Karachi, 13th March 1917

Referring to the interview my architect Mr. Somake and myself had with you the other day pointing out the architectural features of the mosque proposed to be built on Rampart Row, I beg to send herewith a set of three plans for the same with the application on the printed form, and shall be obliged if you will be good enough to grant permission to build same at an early date.

PLAN OF PROPOSED MOSQUE  
TO BE ERECTED ON PLOTS NO 1 & 2, SHEET A.I. OFFICE OF KARACHI  
SCALE 8 FEET TO ONE INCH

ELEVATION TO KHANJA LANE.

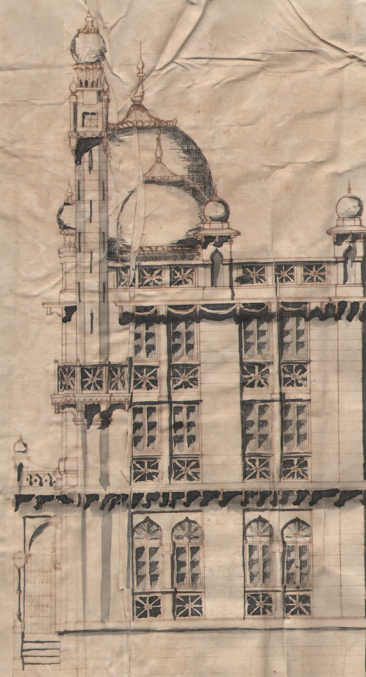
Forwarded to the A.O.C.  
The tower to the north  
in Khoja Lane is  
more than double the  
width of the lane, but  
as this is merely  
for ornamental  
purposes to observe  
the symmetry of the  
building, there  
would appear to  
be no objection  
to approve the  
plan.

Inform owner & C.O.C  
no objection
